CITY OF ALBUQUERQUE

October 28, 2019

RE: **Lot 31 Block 5 S.A.D. 227 Unit 5**
8036 Victoria Dr. NW
Grading and Drainage Plan
Engineers Stamp Date 10/16/19 (E10D067)

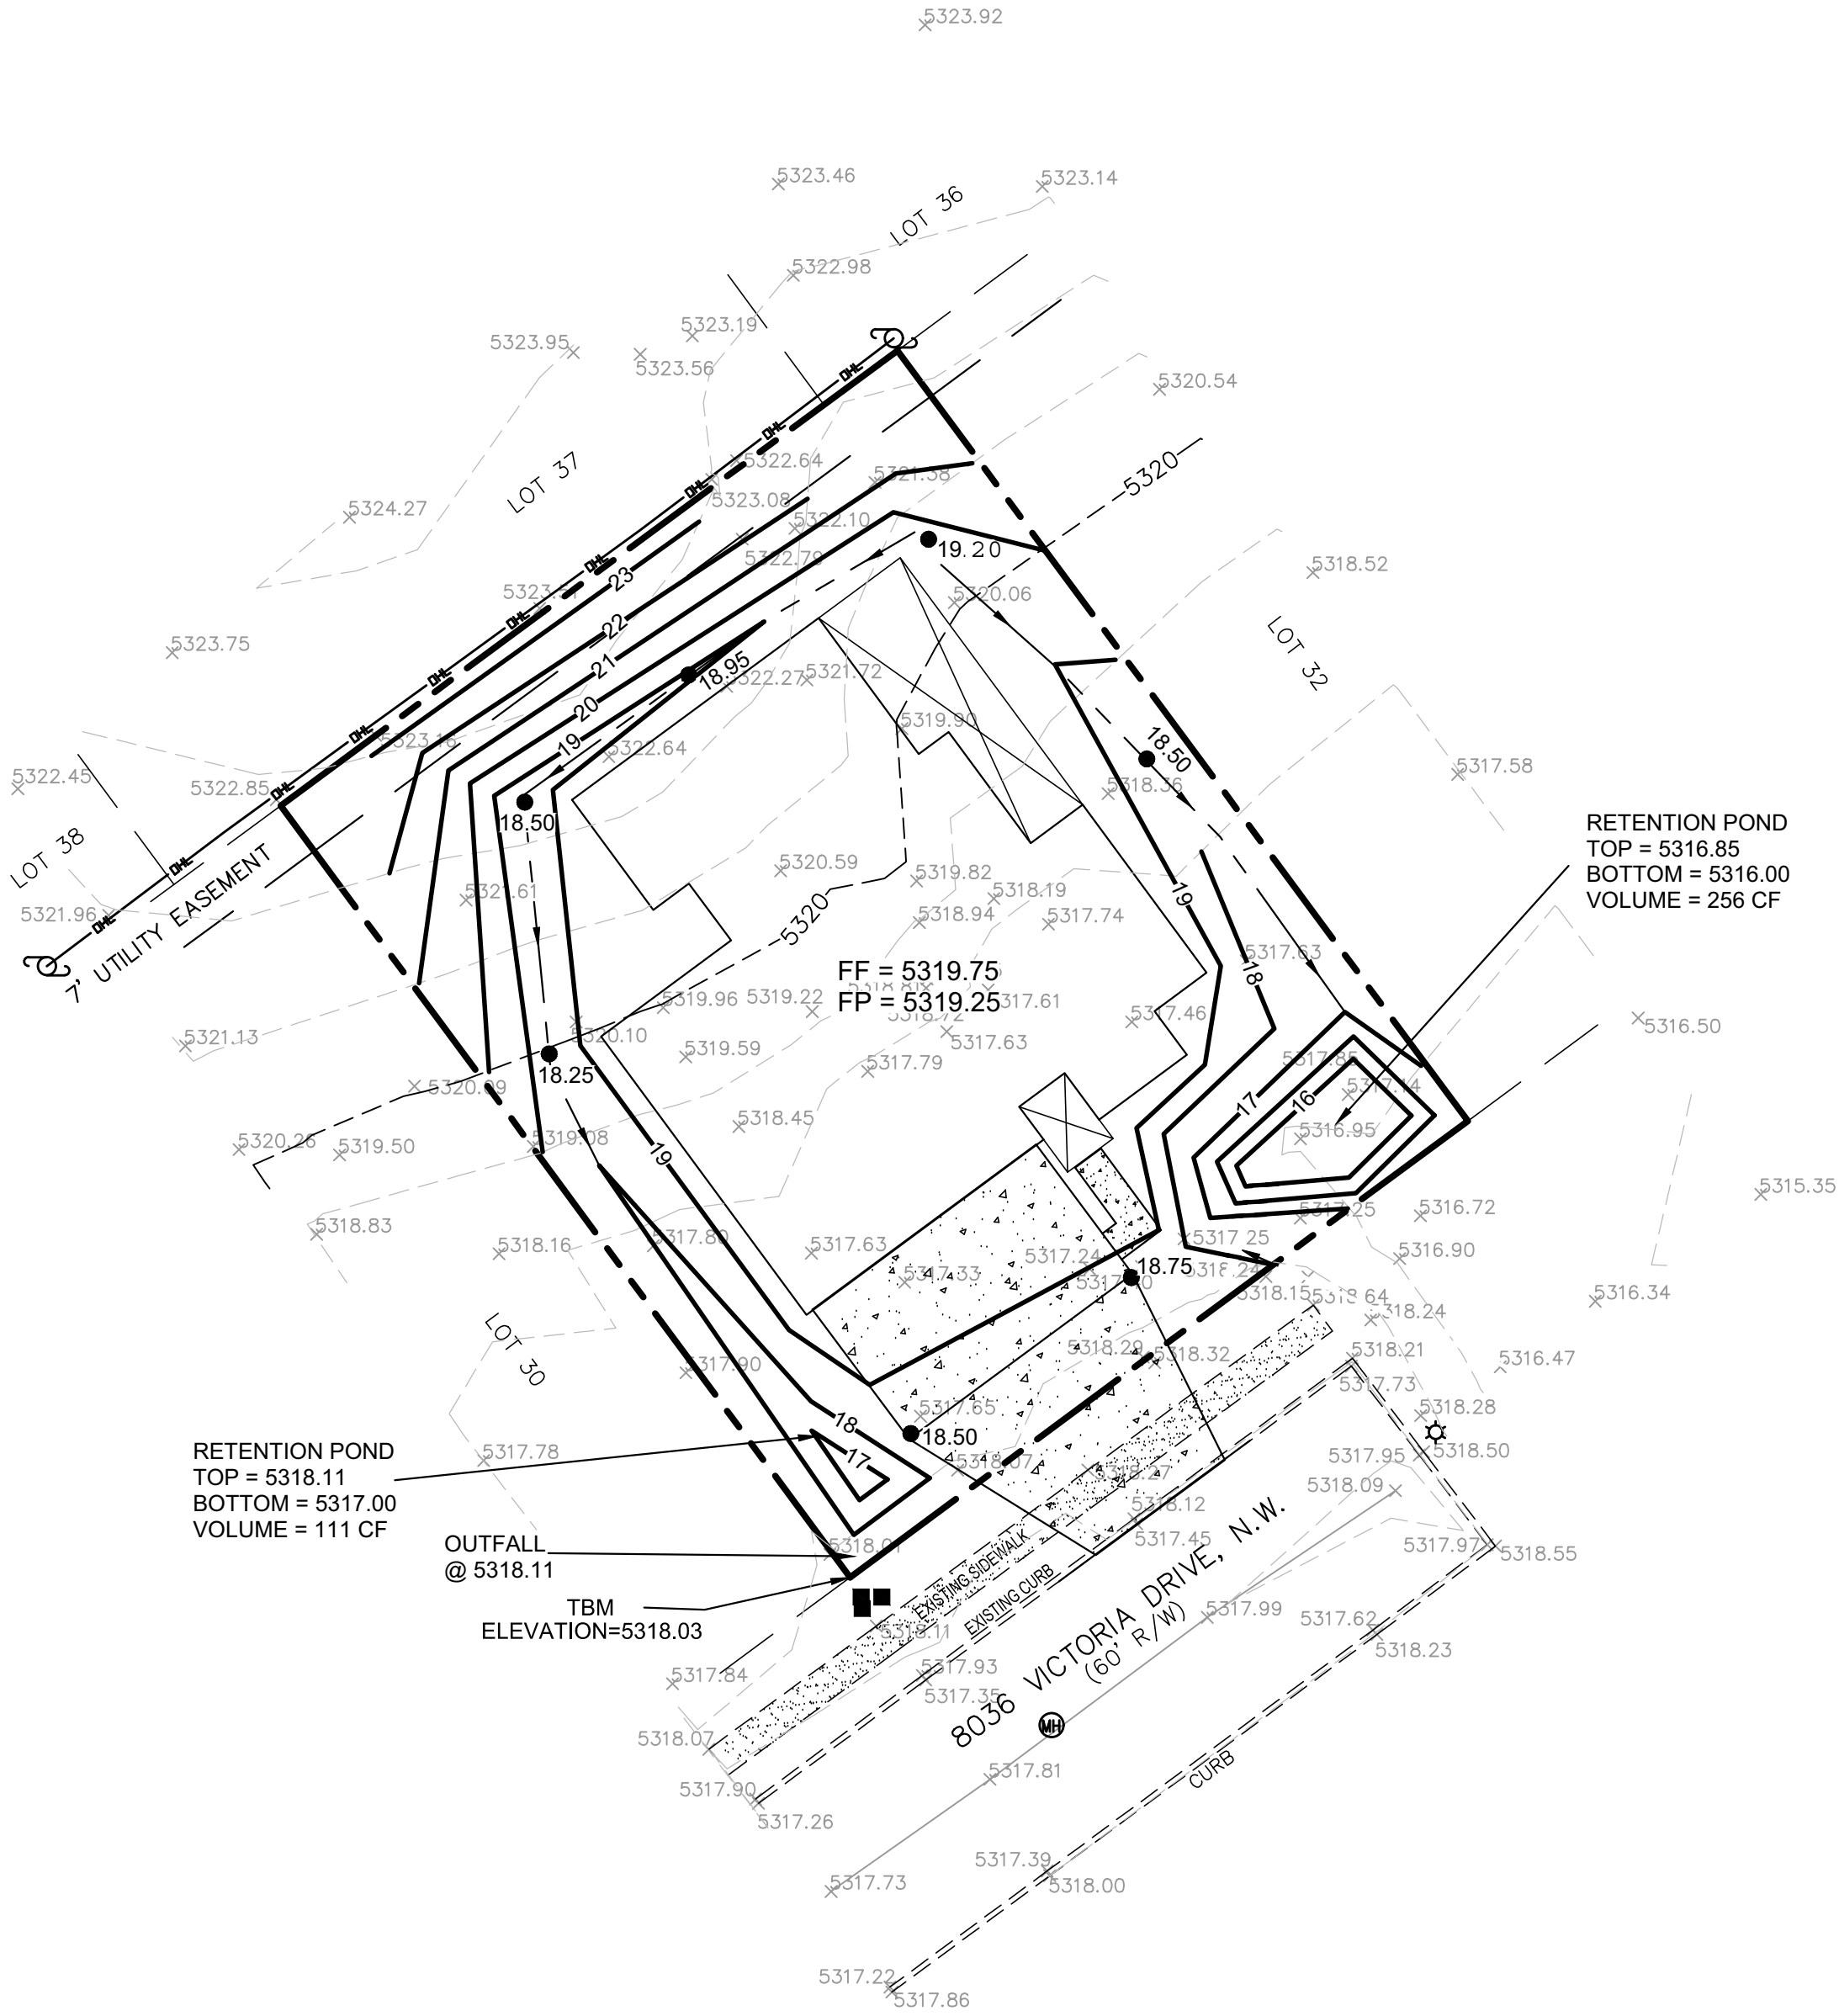
Based upon the information provided in your submittal received 10/21/19, this plan is approved for Grading Permit. Please inform the builder/owner to attach a copy of this approved plan and letter into the construction sets in the permitting process prior to sign-off by Hydrology.

Reiterate to the Owner/Contractor that a separate permit for any garden/retaining wall must be obtained, with the approved G&D plan.

Prior to Building Permit approval, a **Pad Certification** will be required. Inform the contractor/owner not to pile dirt in the street as a ramp to climb the curb. If dirt is found in the street the pad cert. will be denied.

Prior to **Certificate of Occupancy release**, Engineer Certification per the DPM checklist of this plan will be required.
